ECE/TRANS/SC.3/WP.3/2009/19
25 March 2009

EUROPEAN CODE FOR INLAND WATERWAYS (CEVNI)

Amendments to Annexes to CEVNI

Proposal submitted by the Chairman of the informal working group on CEVNI

- 1. Marking

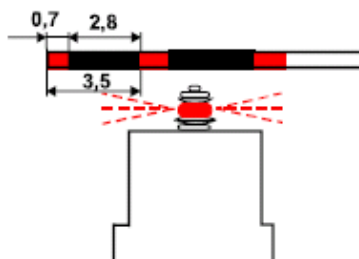
- (a) Add a new paragraph 1 as follows

The waterway, the fairway, as well as the danger points and obstacles are not always marked.

Buyos, when used, shall be anchored at approximately 5 m distance from the limits that they indicate.

Groynes and shallows can be marked using fixed marks or buyos. These marks or buyos shall, usually, be placed on the borders of groynes and shallows or in front of them.

It is necessary to keep a sufficient distance from the marks and the buyos to avoid the risk of getting on the ground or hitting an obstacle.

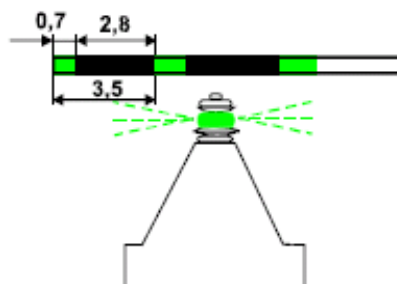
(a) In Figure 1 between the second and the third image add the following drawing

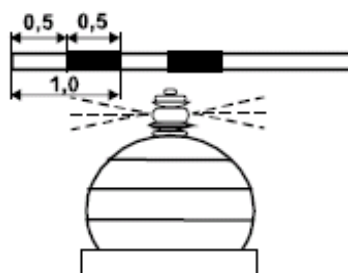
(a) In Figure 2, between the second and the third image add the following drawing

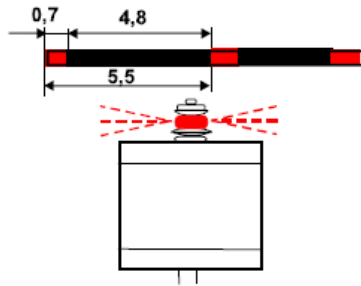
(a) In Figure 3, between the second and the third image add the following drawing

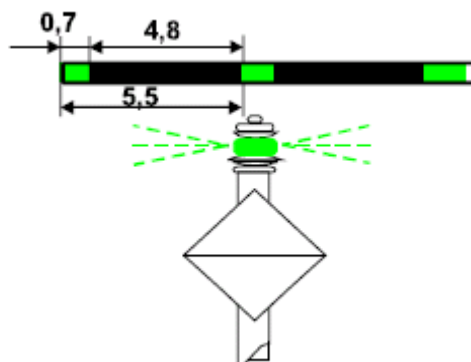
(a) In Figure 6, delete the second drawing

(b) In the paragraph on topmark delete or square frame (sides horizontal and vertical), painted green

(c) Add the following drawing

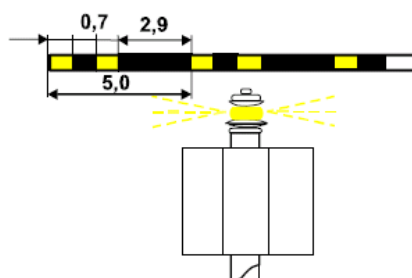
(a) In Figure 8, delete the second drawing

(b) In the paragraph on topmark delete or a lath-assembled St. George's Cross, painted yellow

(c) Add the following drawing

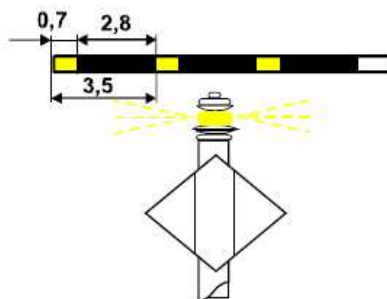
(a) In Figure 9, delete the second drawing

- (b) In the paragraph on topmark delete or a lath-assembled St.George's Cross, painted yellow
- (c) Add the following drawing

3.2 Identification of the axis of a long cross-over

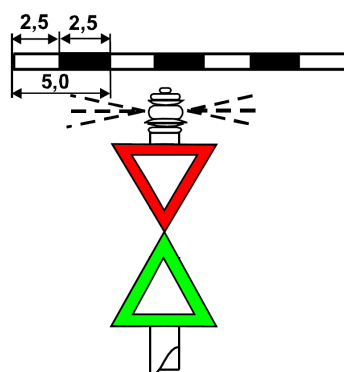
- (a) Amend the text of paragraph 3.2 as follows

Two identical signs placed one behind the other on the same bank, the **first sign positioned lower than the second one**, forming an alignment [...].

Lights (if any): yellow (the forward light and rearward light generally having the same rhythm; however, the rearward light may be a fixed light).
